**LAND USE APPLICATION SUMMARY**

*Property Location:* 3621 Bryant Avenue S  
*Project Name:* 3621 Bryant Avenue S 4-Plex  
*Prepared By:* Kimberly Holien, Principal Planner, (612) 673-2402  
*Applicant:* Farkas Wagner, LLC  
*Project Contact:* James Graham, Cundy, Santine and Associates, Architects  
*Request:* To reduce the north and south interior side yard setbacks for a new four-story residential building with four dwelling units.

## Preliminary Development Review Report

New 4 story, 4 plex

### 3 A1 Site Plan

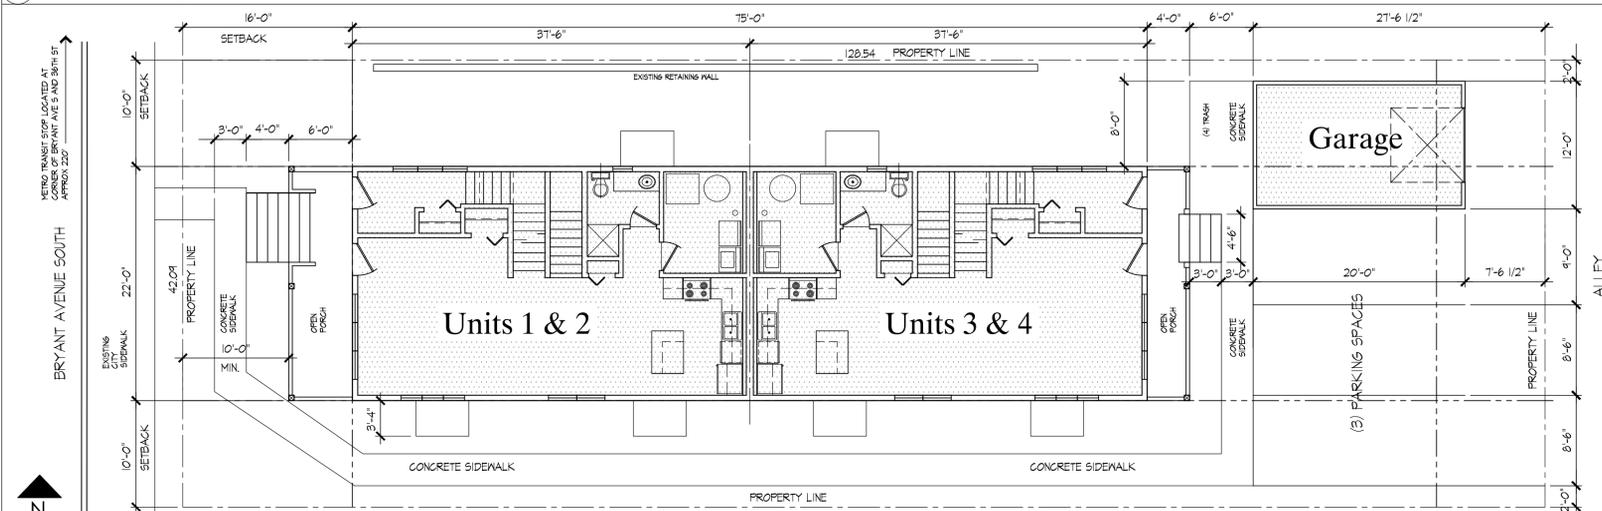
- The side yard set backs require a variance.
- Please continue to work with Kimberly Holien for this process.

- Current ordinance states that all maneuvers associated with loading, parking or sanitation pick up for a private development shall occur on private property. Please provide a narrative explaining the trash removal operations. Per City Ordinance the Applicant shall provide for (and identify) a solid waste collection point (SWCP) on the site plans. The location of the SWCP is subject to the review and approval of the Public Works Department.

- All existing and proposed underground Public Utilities (water, sanitary sewer, and storm drain) shall be shown on the site plan with corresponding pipe sizes and types. For Public watermain infrastructure records call (612) 673-2865. Any existing water service connections to the site shall be noted on the plans for removal, and shall be removed per the requirements of the Utility Connections Department before any new service lines can be installed, call (612) 673-2451 for more information.

- Groundwater: Please include the low floor elevation on the Grading Plan and identify if discharge of groundwater is proposed in order to keep the below grade portions of the building dry after construction. If not, please clearly indicate this.
